PIC18F1230/1330 Data Sheet Errata

Clarifications/Corrections to the Data Sheet:

In the Device Data Sheet (DS39758C), the following clarifications and corrections should be noted. Any silicon issues related to the PIC18F1230/1330 will be reported in a separate silicon errata. Please check the Microchip web site for any existing issues.

FIGURE 6-3: TABLE POINTER BOUNDARIES BASED ON OPERATION

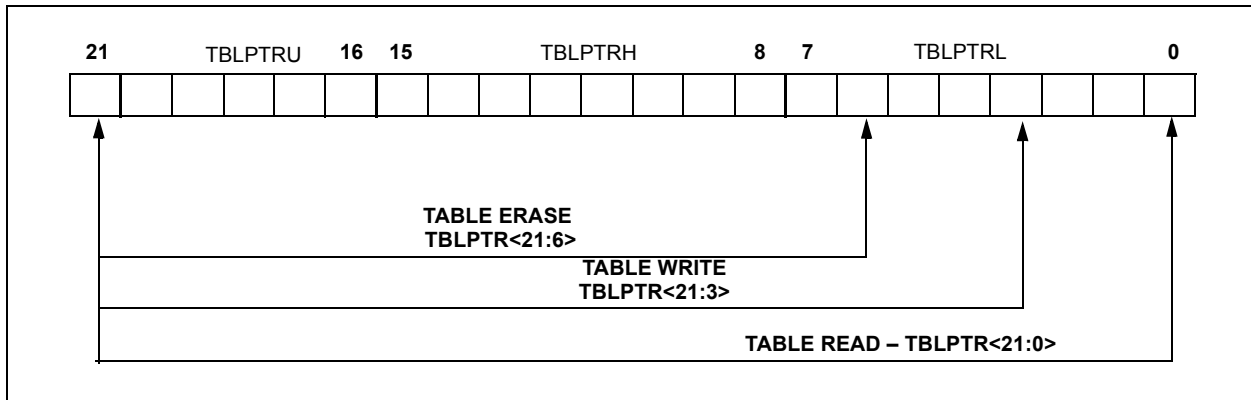
In **Section 6.2.4 “Table Pointer Boundaries”**, the third paragraph and Figure 6-3 are modified:

- Figure 6-3 is modified as shown.

- The paragraph is modified by the removal of the first sentence and the addition of new text shown in bold.

When the timed write to program memory begins (via the WR bit), the 19 MSBs of the TBLPTR (TBLPTR<21:3>) determine which program memory block of 8 bytes is written to. **The Table Pointer register’s three LSBs (TBLPTR<2:0>) are ignored.** For more detail, see **Section 6.5 “Writing to Flash Program Memory”**.

FIGURE 17-1: COMPARATOR VOLTAGE REFERENCE BLOCK DIAGRAM

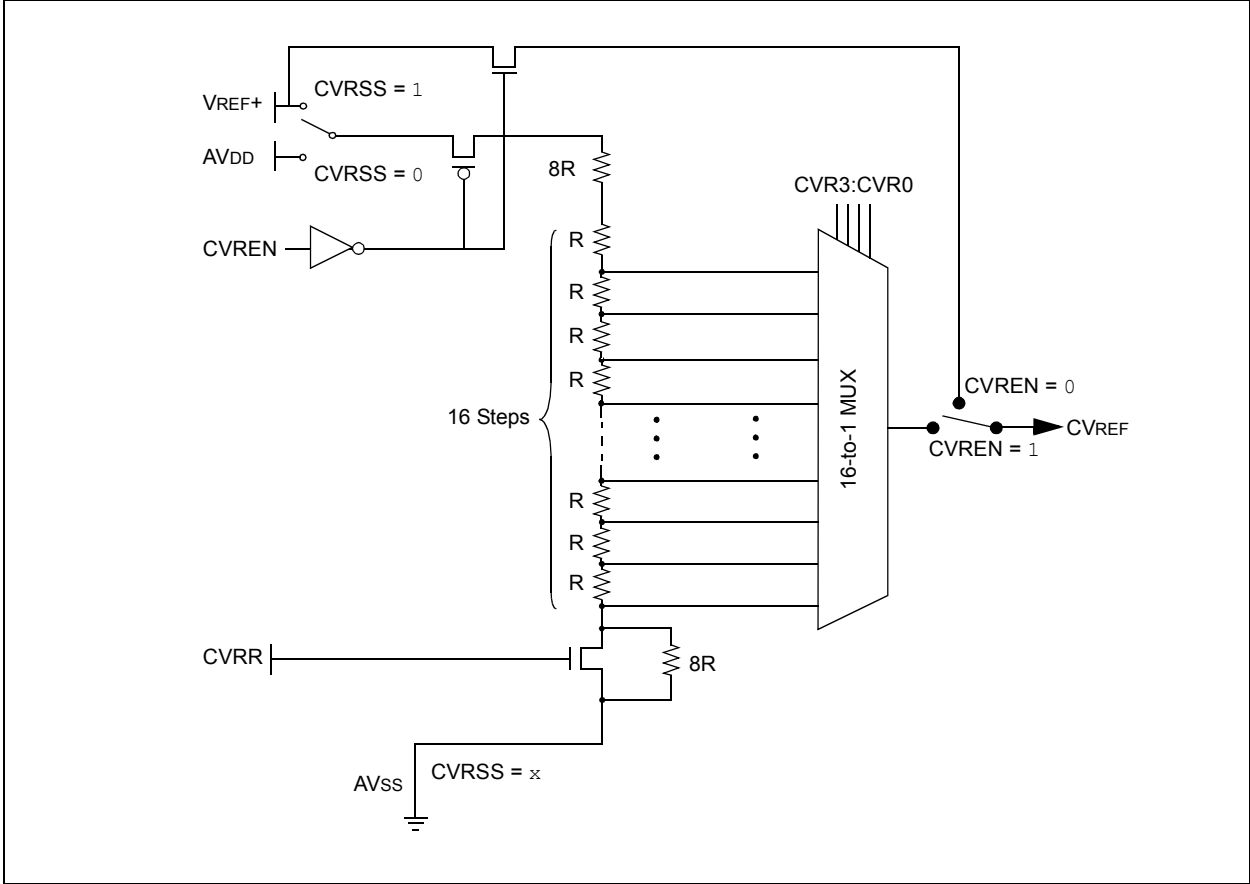
- Add new text and a table (Table 17-1) about the voltage reference being able to select the unscaled VREF+ for comparator input
- Modify Register 17-1 (CVRCON) with a new description of bit 4 (CVRSS)
- Revise Figure 17-1

The textual changes break the last sentence of the first paragraph of **Section 17.1 “Configuring the Comparator Voltage Reference”** into a second paragraph and adds content. The incorporation of the three bulleted changes are shown, with new or altered text indicated by bold face.

The comparator reference supply voltage can come from either AVDD or AVSS, or the external VREF+ that is multiplexed with RA4 and AVSS. The voltage source is selected by the CVRSS bit (CVRCON<4>).

Additionally, the voltage reference can select the unscaled VREF+ input for use by the comparators, bypassing the CVREF module. (See Table 17-1 and Figure 17-1.)
